SUNNINGDALE PARISH COUNCIL

23/02160PT20A - 56 - 78 Beverley Court Cedar Drive Sunningdale Ascot

Construction of additional storey to provide 4 no flats

2302163/PT20A - 26 - 54 Beverley Court Cedar Drive Sunningdale Ascot

Below is the current 26-54 Beverley Court and the proposed:

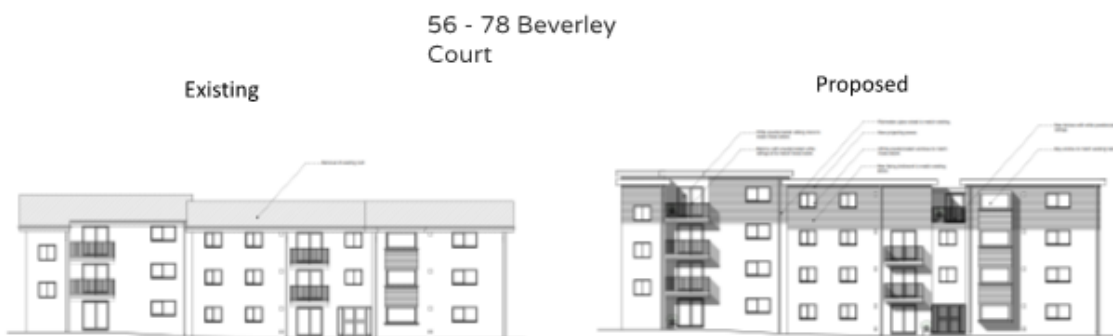
The proposed works relate to two blocks of flats in Cedar Drive. These applications propose the building of an addition storey on both these blocks, turning them from 3 storey blocks to 4 storey blocks.

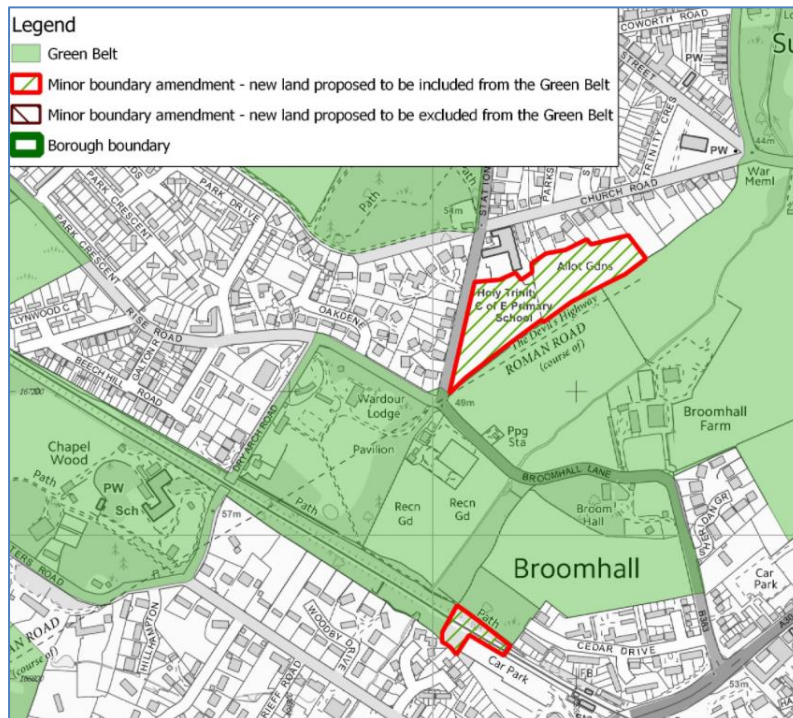
The contrast in adjacent roof heights is marked. This can be seen in the eaves height of the house 24B Cedar Drive (shown below in blue outline) and the proposed Eastern elevation of the new block which is only metres away. The height of the new storey will be more than twice the height of the eaves of 24B and the garden would be cast into shade for a greater part of the day.
